Varimixer

Improved lifting lever for better ergonomics

AR30 + AR40 + AR60

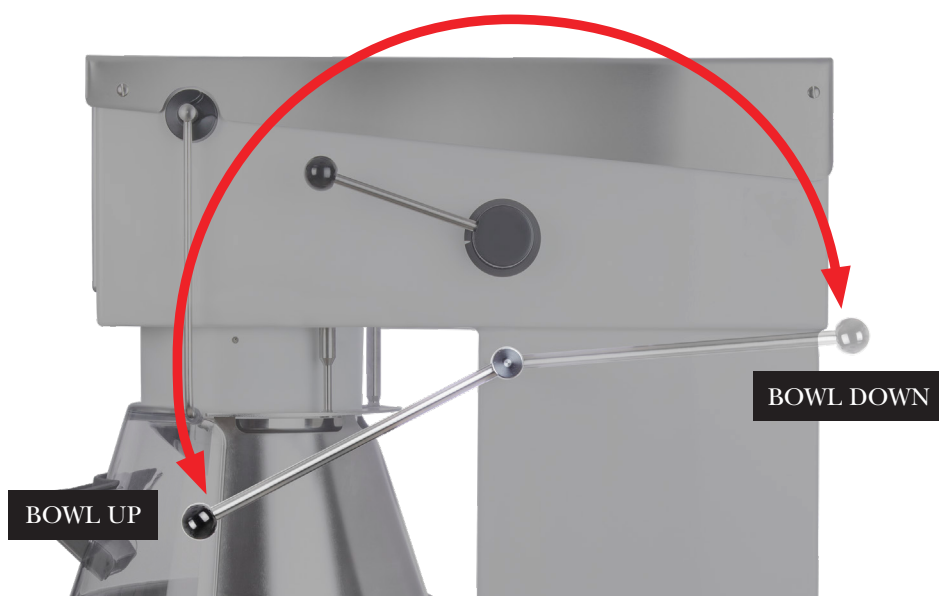
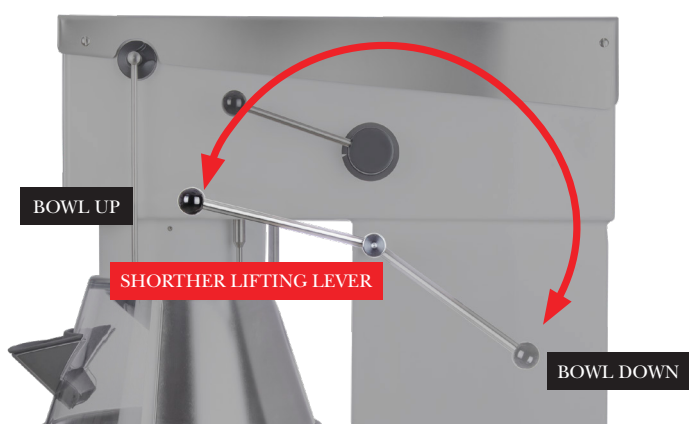
NEW POSITION

The ball is now attached to the shaft with a solid thread to gain robustness and avoid glue attachment.

New design achieves:

- Use less force when raising the bowl (Law of the lever logic)
- Better ergonomic work position
- Bigger spacing between speed / lifting lever
- Shorter reach

AR30 + AR40:

- Longer lifting lever (compared to earlier models)
- Different angle / position

AR60:

- Same lifting lever (compared to earlier model)
- Different angle / position

OLD POSITIONS
